**RE: Encompass Health
7000 Jefferson NE
Grading Plan Stamp Date: 10/17/19
Hydrology File: D17D061A**

RE: **Encompass Health**
7000 Jefferson NE
Grading Plan Stamp Date: 10/17/19
Hydrology File: D17D061A

Reference: Encompass Health
7000 Jefferson NE
Grading Plan Stamp Date: 5/23/19
Hydrology File: D17D061A

DRAWING NO:
C3.1

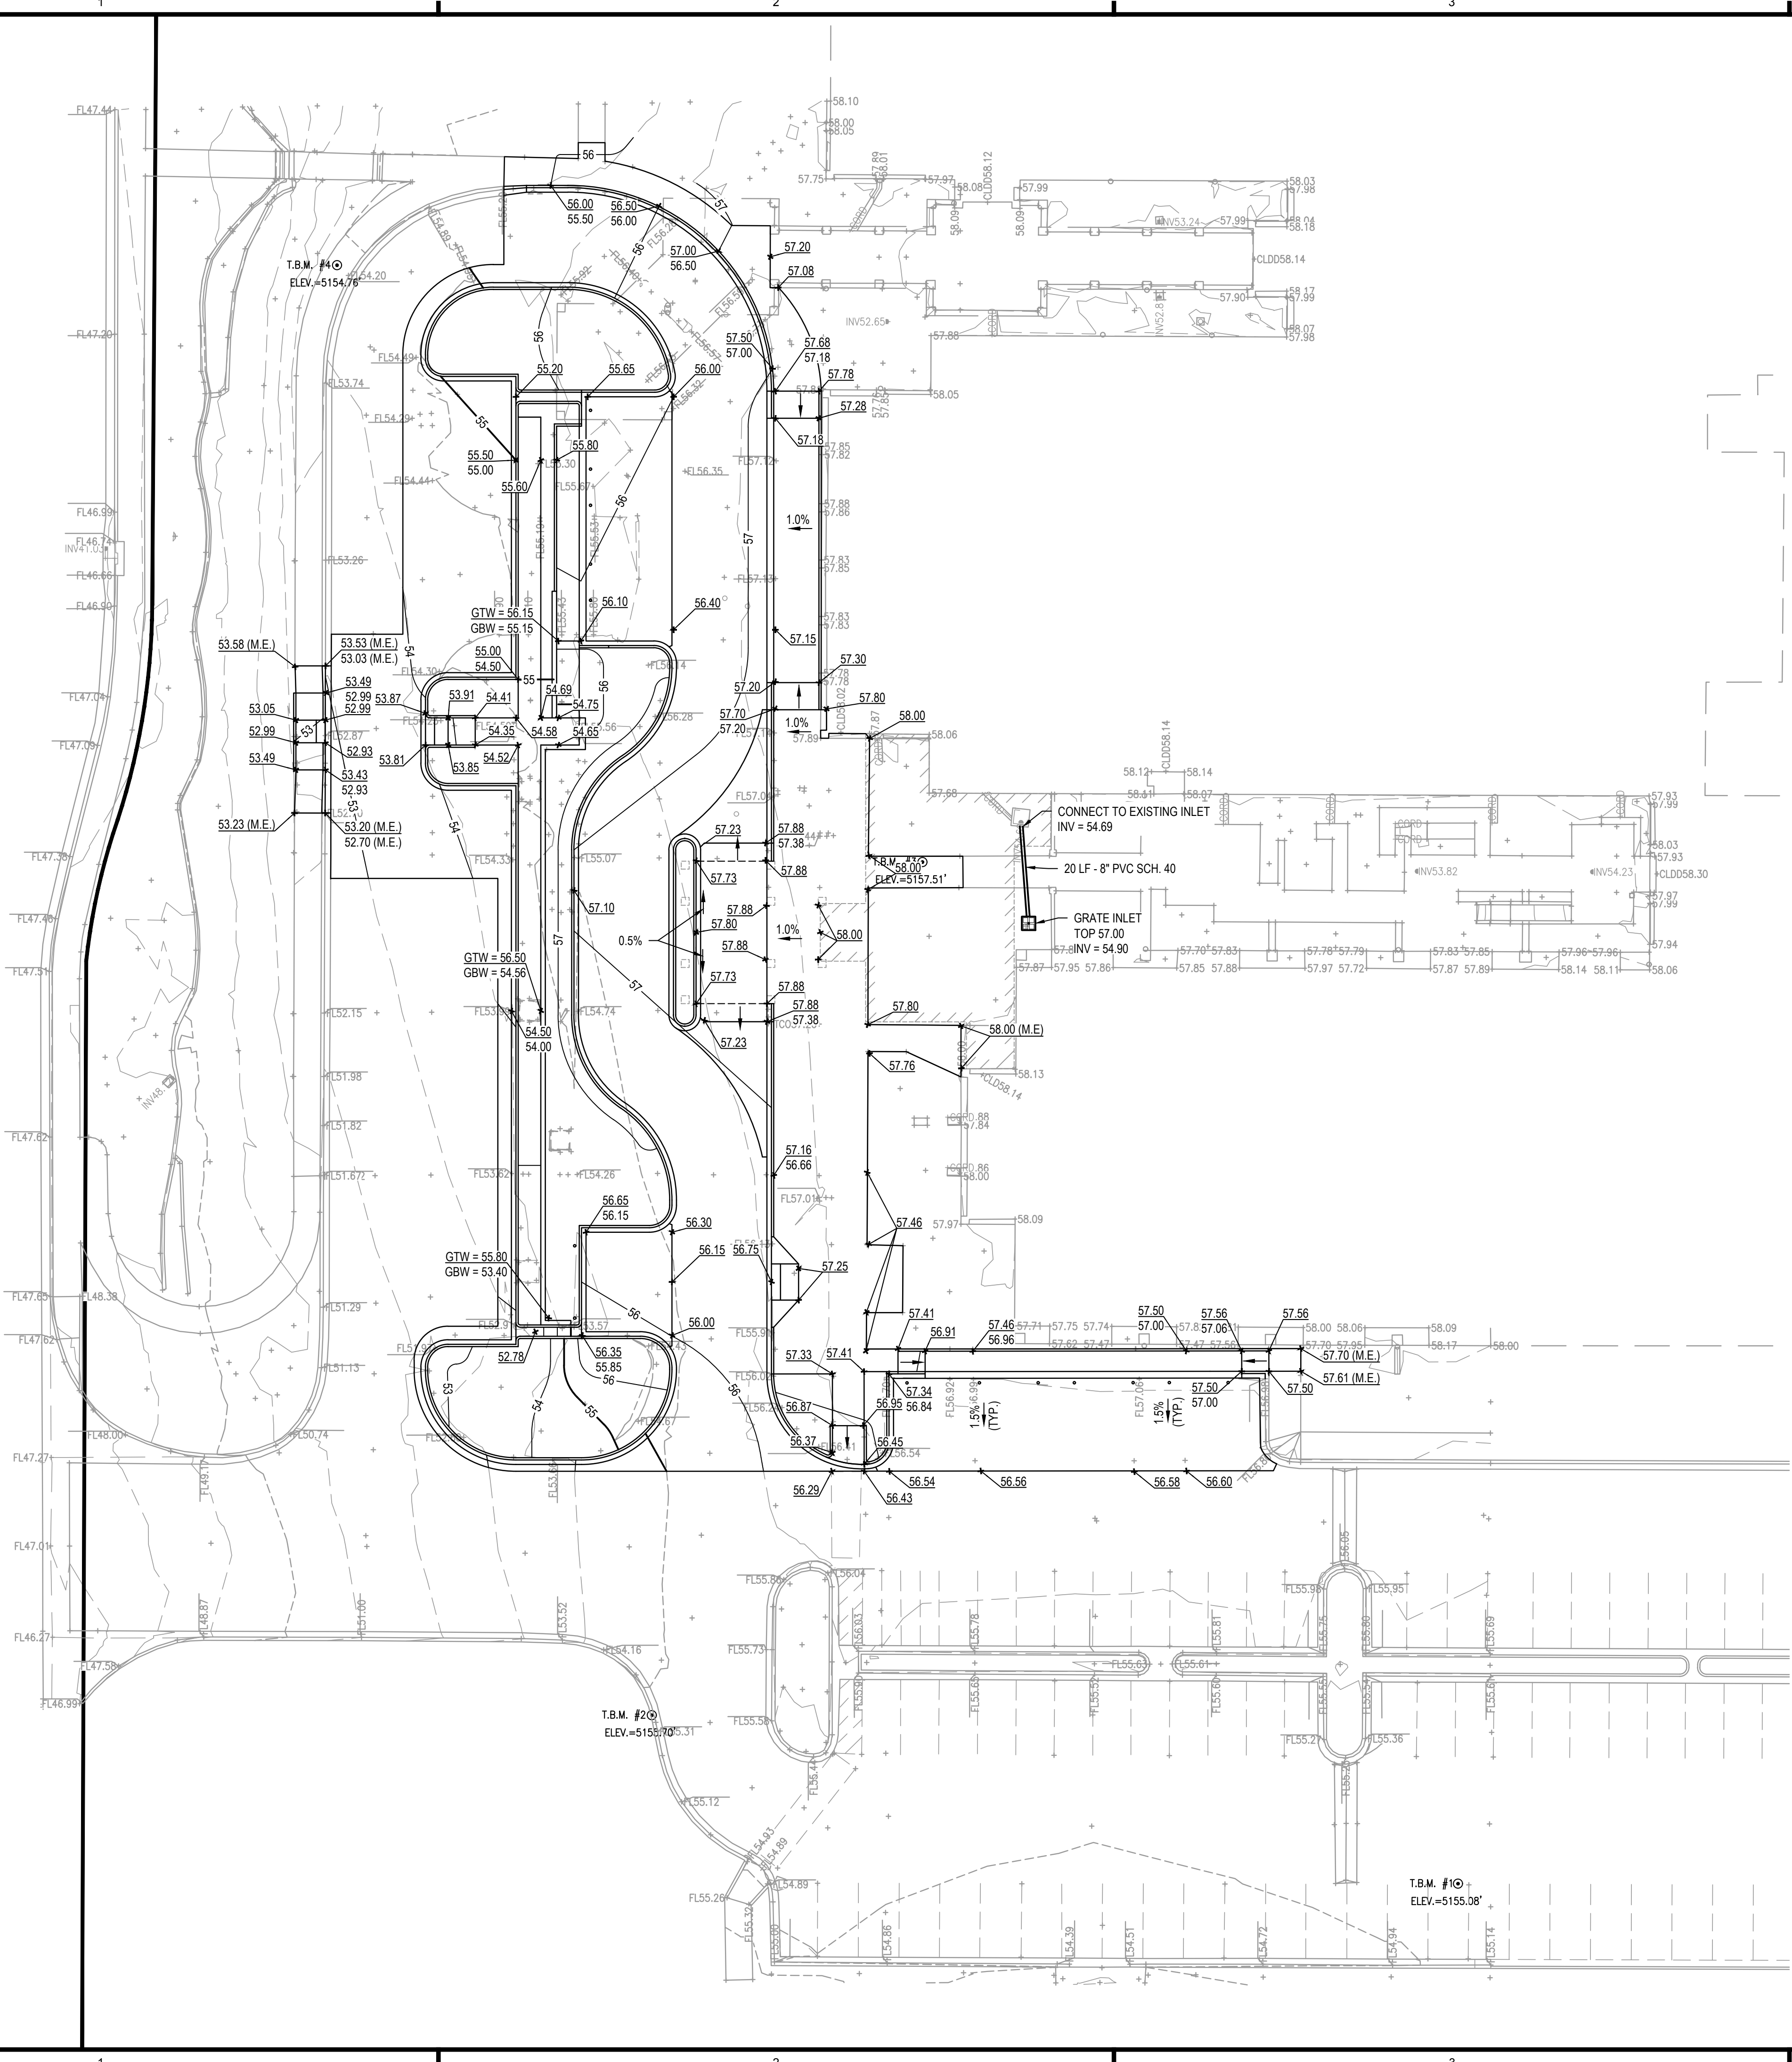
12. Provide hydraulic calculations as needed, per the DPM, Ch 22.3 for the 100-yr storm. Hydraulic calculations are required on any curb openings, weirs, swales, new storm drain, ponds, etc.

Response: A landscaping inlet was added and hydraulic calculations have been provided for the 100-yr storm on Sheet C3.1.
